EXPLANATION OF SIGNIFICANT DIFFERENCES

ONONDAGA LAKE BOTTOM SUBSITE OF THE ONONDAGA LAKE SUPERFUND SITE

MODIFIED PROTECTIVE CAPS

March 2018

Figure 2
Modified Erosion Resistant Cap
Metro Deep Water Outfall

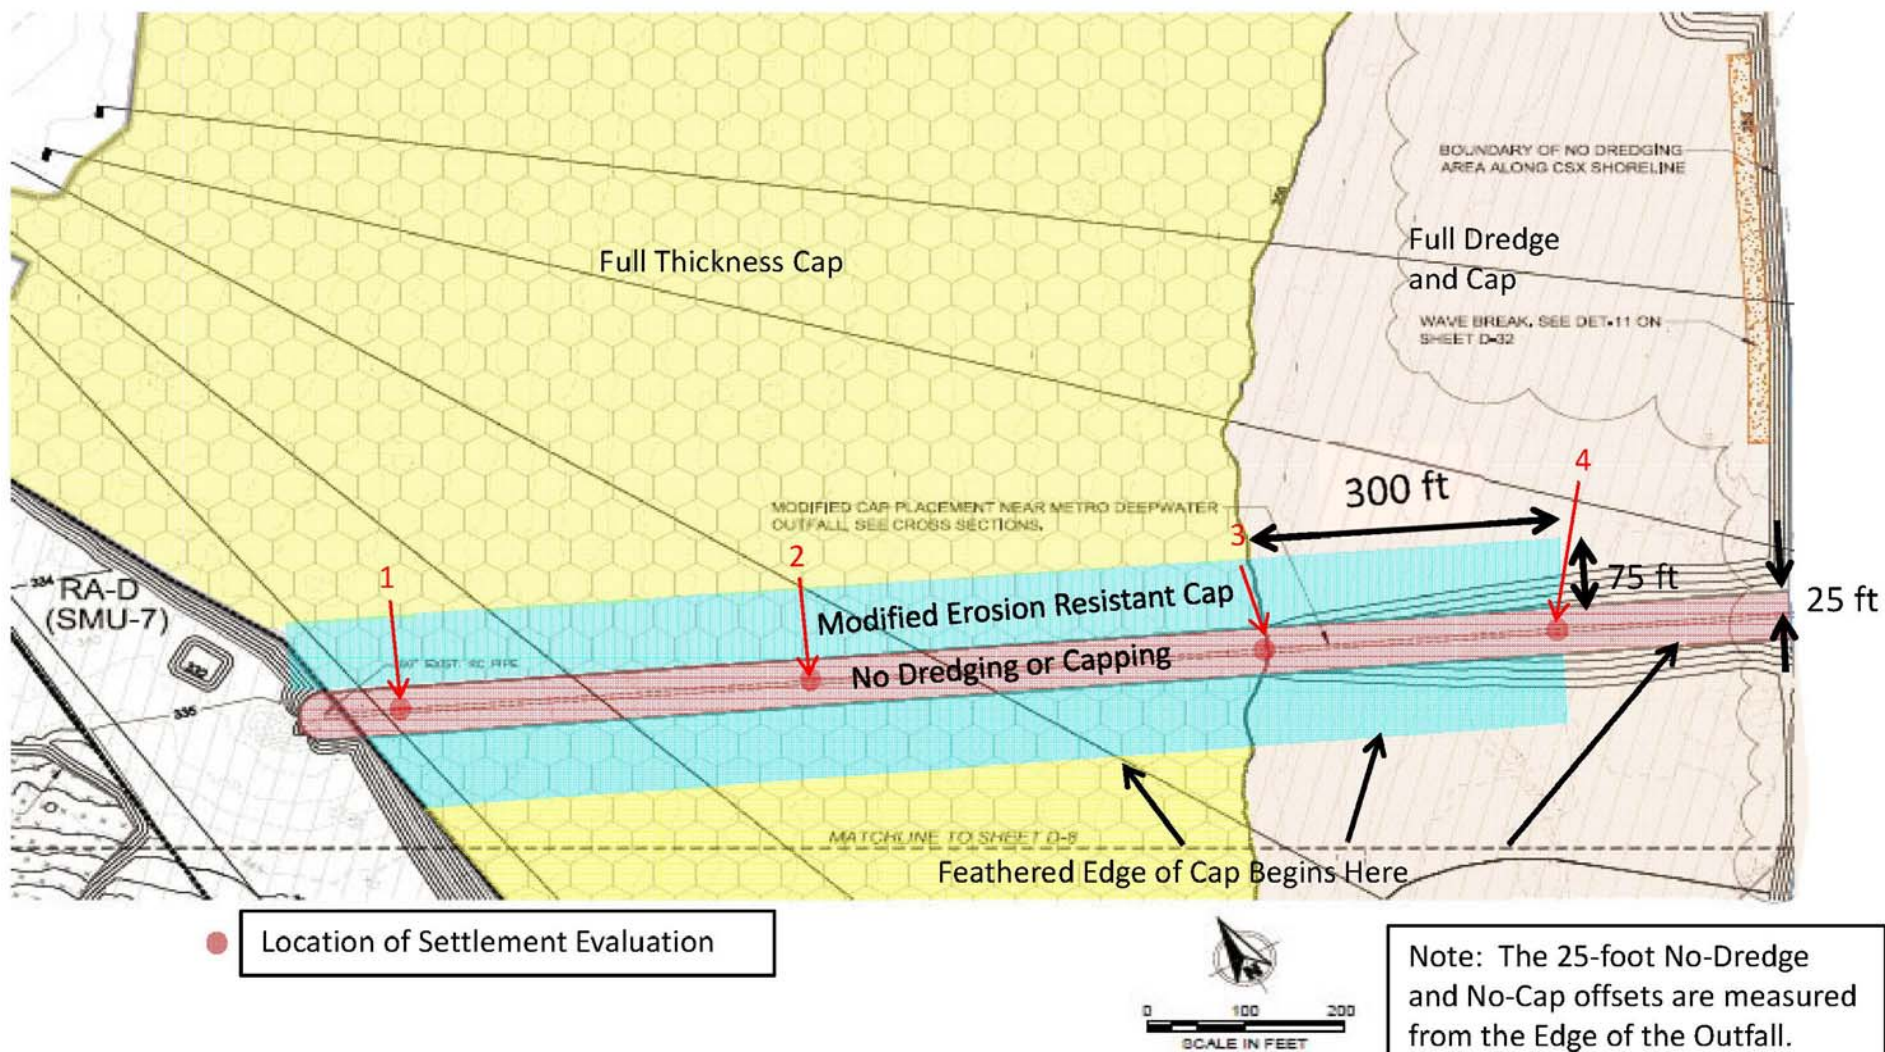
A Design Addendum (Parson and Anchor QEA, 2014) for this area was submitted in October 2014 and approved by NYSDEC in October 2014. The revised remedial approach in the vicinity of the deep water outfall pipeline is shown in Figure 2 and includes the following:

- No dredging or capping above the 6-foot diameter pipeline and within 25 feet of the pipeline on each side (total width of 56 feet).
- A MERC in the zone between 25 feet and 100 feet of the pipeline in areas where there is minimal or no dredging prior to capping. This cap included 6 inches of gravely sand amended with granular activated carbon (GAC), which is the maximum cap thickness and coarsest substrate that can be applied in this area based on cap stability considerations (as documented in Attachment 1 of Parsons and Anchor QEA, 2014). This will help reduce scour and resuspension of underlying sediments because of wind/wave action, but it may not be coarse enough to meet the predicted erosive force of a 100-year storm event, which is the design basis for the surrounding area. Because of the reduced cap thickness, the cap surface elevation in this area will be approximately 2 feet lower than the surrounding cap elevation, which will reduce erosive forces in this area.

- Revised cap chemical isolation modeling. This modeling was completed based on a cap thickness of 6 inches, resulting in higher GAC application rates than for the full thickness cap specified in the Final Design (2012). The revised cap modeling in this area is summarized below and details of the modeling are provided in Attachment 2 of Parsons and Anchor QEA, 2014.
- Cap transitions from the modified cap to the full thickness cap in areas where the MERC was placed, between approximately 100 to 150 feet of the pipeline, with incremental increases in cap thickness to avoid significant differential cap loading in the transition zone.

FIGURE 3

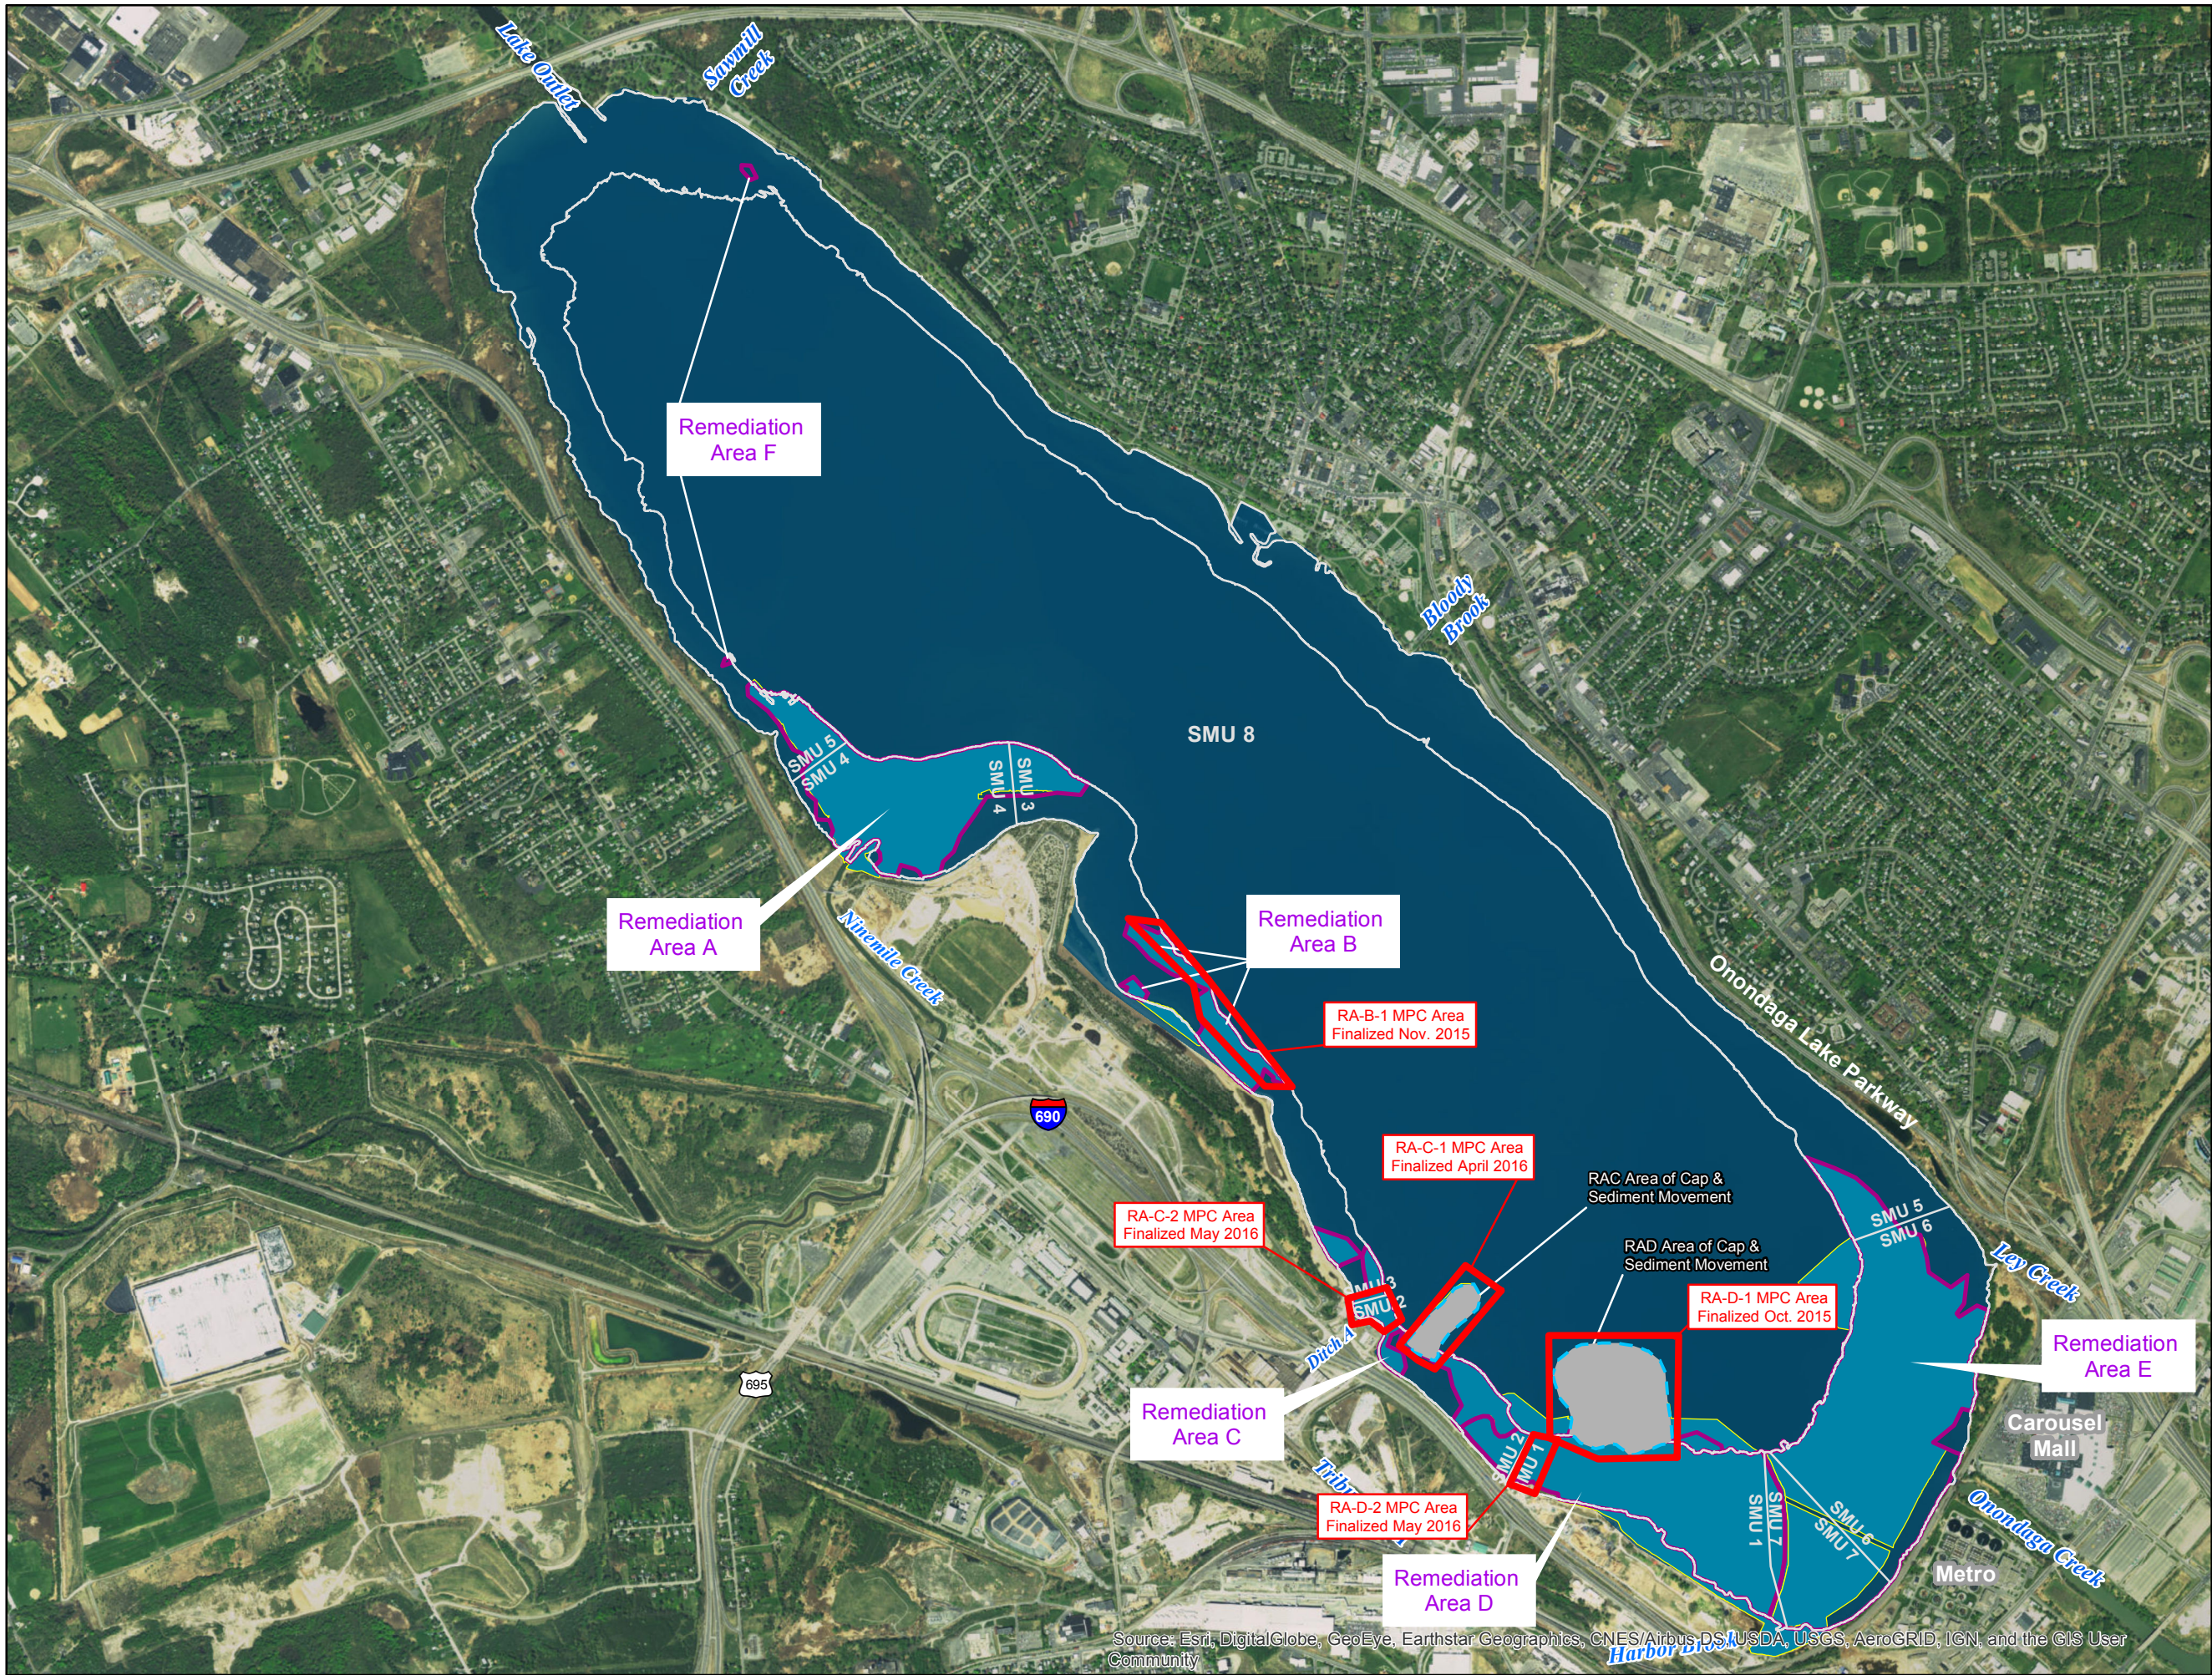
Design revisions were developed for the MPCs in five areas of the Lake as shown in Figure 3. These design revisions were reviewed and approved by NYSDEC prior to construction of the MPCs in 2015 and 2016. Table 1 provides a summary of the MPC acreages and cap types in each of these areas.

Figure 4
Modified Protective Caps
Remediation Area B
Onondaga Lake

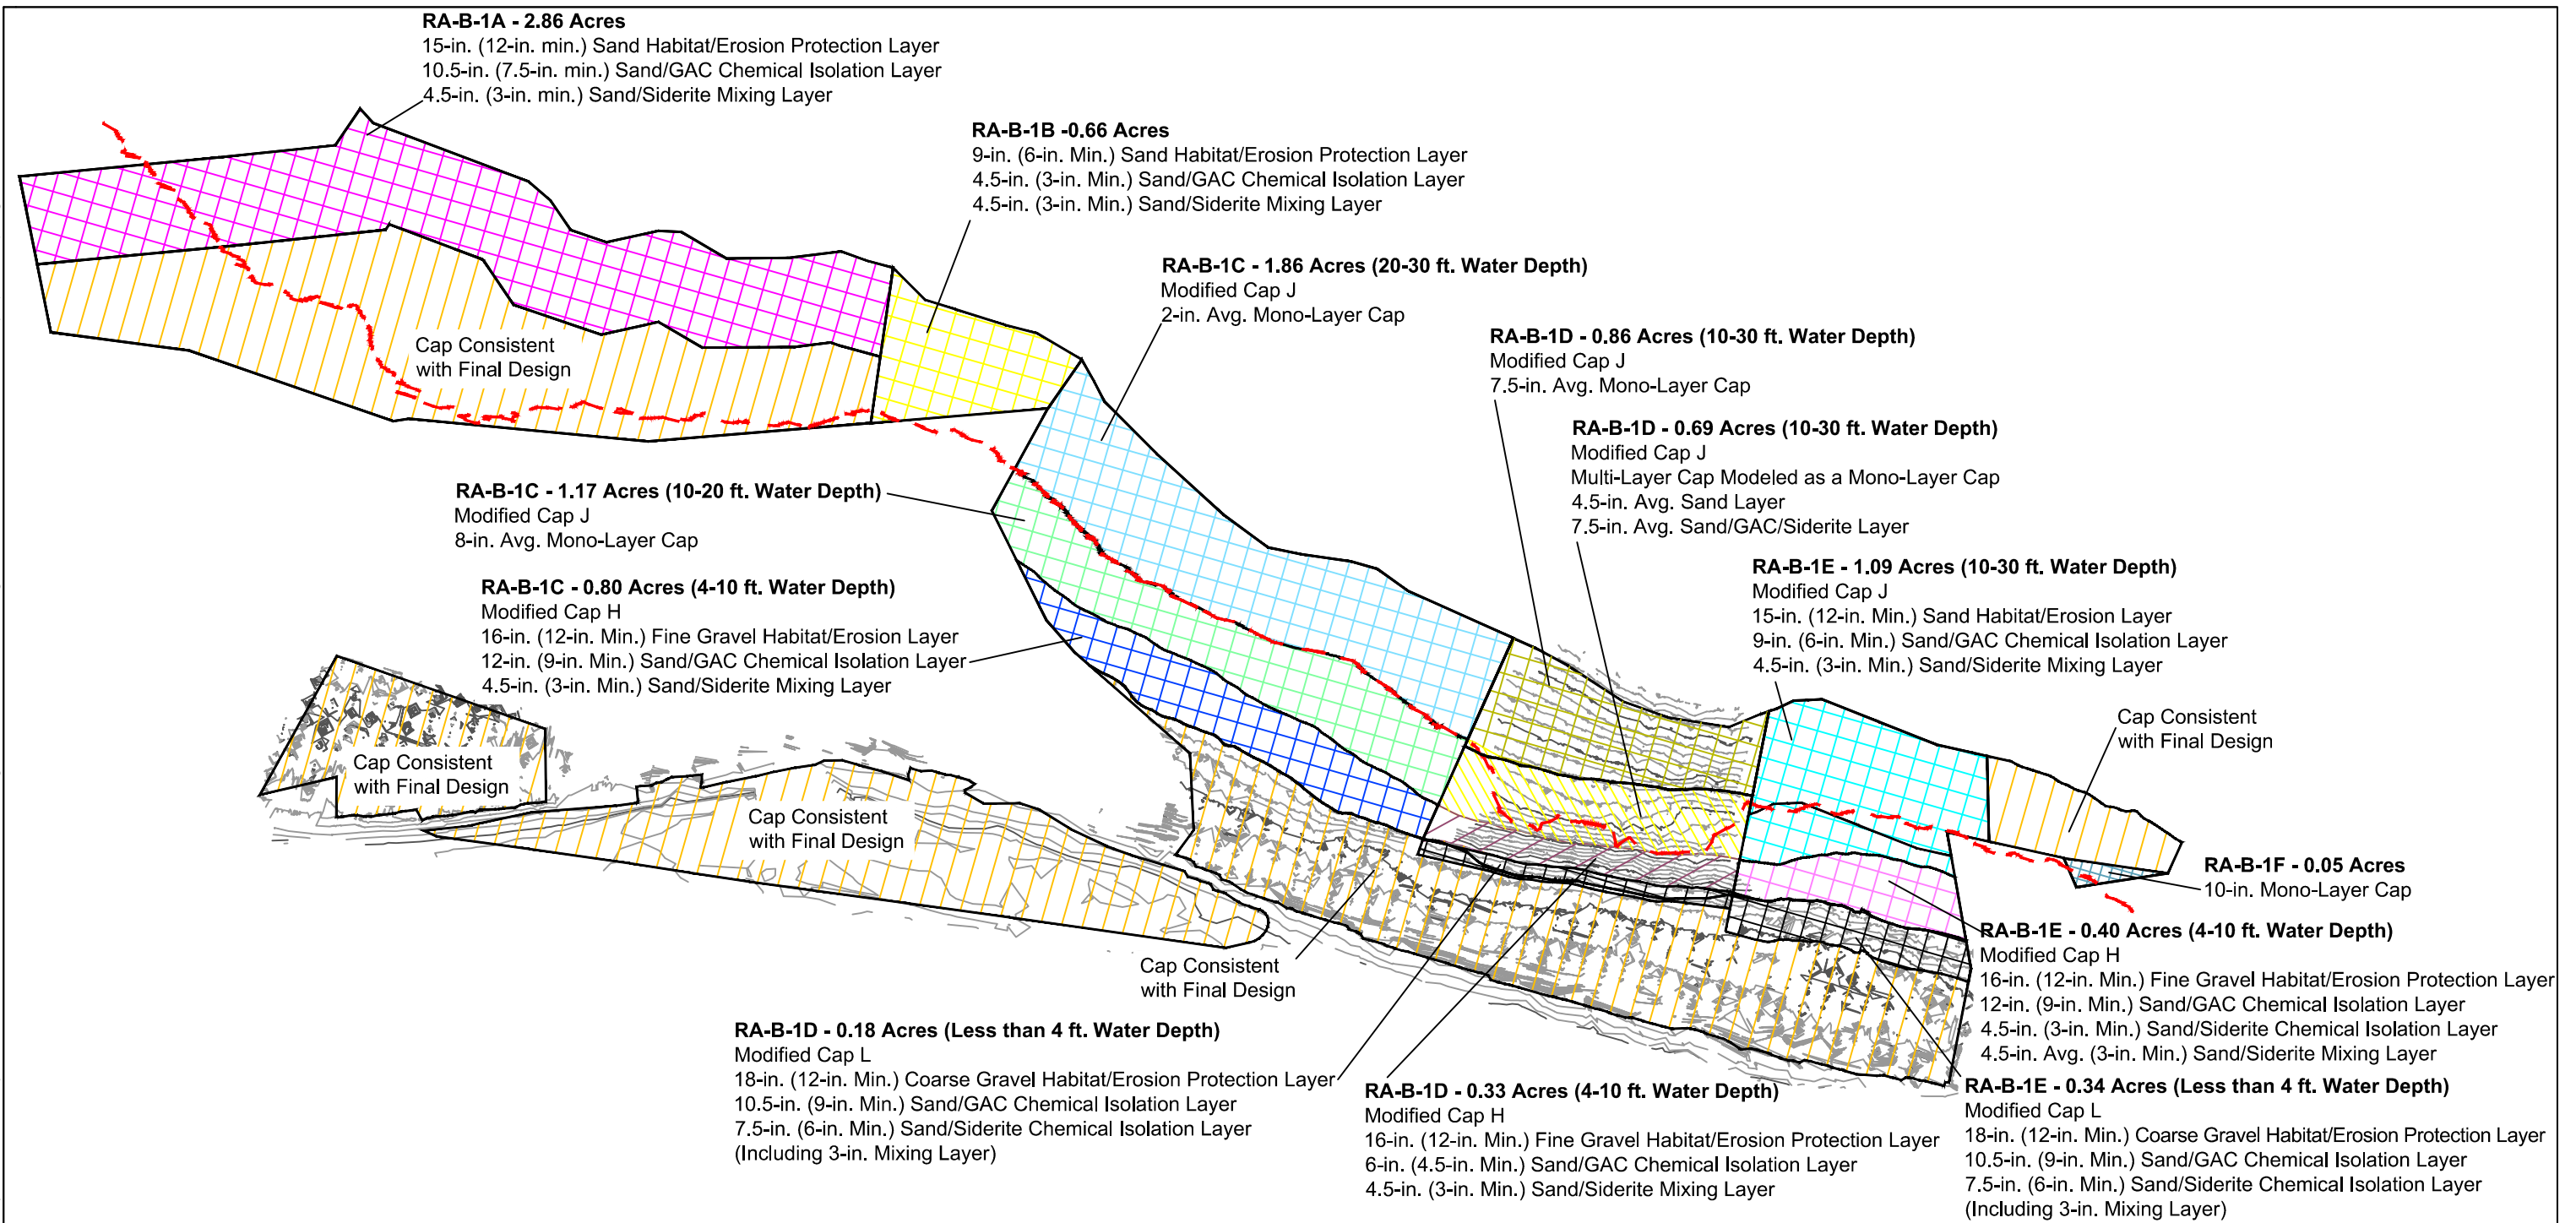
- **RA-B-1:** As shown in Figure 4 and presented in Table 1, approximately 6 acres of the total MPC area in RA-B (11.3 acres) consist of a multi-layer cap with a minimum 12-inch habitat/erosion protection layer; approximately 5.1 acres of this area has a reduced thickness isolation layer as compared to the ROD minimum of 12 inches.³ An additional 0.7 acres consist of a multi-layer cap with a minimum 6-inch habitat/erosion protection layer and a reduced

thickness isolation layer (less than the minimum of 12 inches). The remaining 4.6 acres consist of mono-layer amended caps of varying average thicknesses ranging from 2 to 10 inches.
